Local Review Body

Planning Application for Review

Change of use from office to café with extension to building, construction of chimney and erection of bin enclosure:
18 Pottery Street, Greenock (09/0083/IC)

Fig 13: Section indicating use of the feature chimney to conceal the mechanical extraction and air inlet

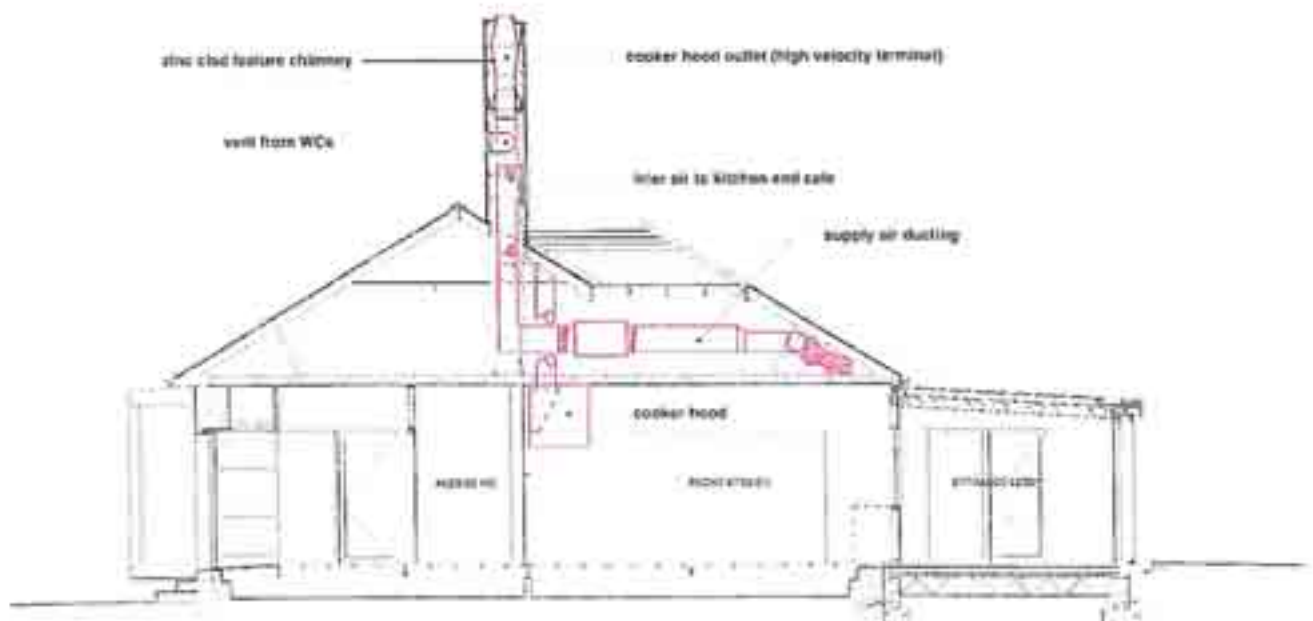
Planning have advised that it is their opinion that the argument for installing the new feature chimney to deal with mechanical extraction from the cooker hood is negated due to Safer Communities advice that this can be achieved below eaves level. However, this is not feasible for the following reasons:

- This is technically impractical. There is a lack of headroom for ducting or spare room for plant equipment on the ground level. Therefore, the mechanical extraction equipment is located in the attic and cannot drop back down through the ceiling and out the walls.

The diagrams below indicate the unsightly alternatives to using the feature chimney to conceal the mechanical extraction and air inlet.
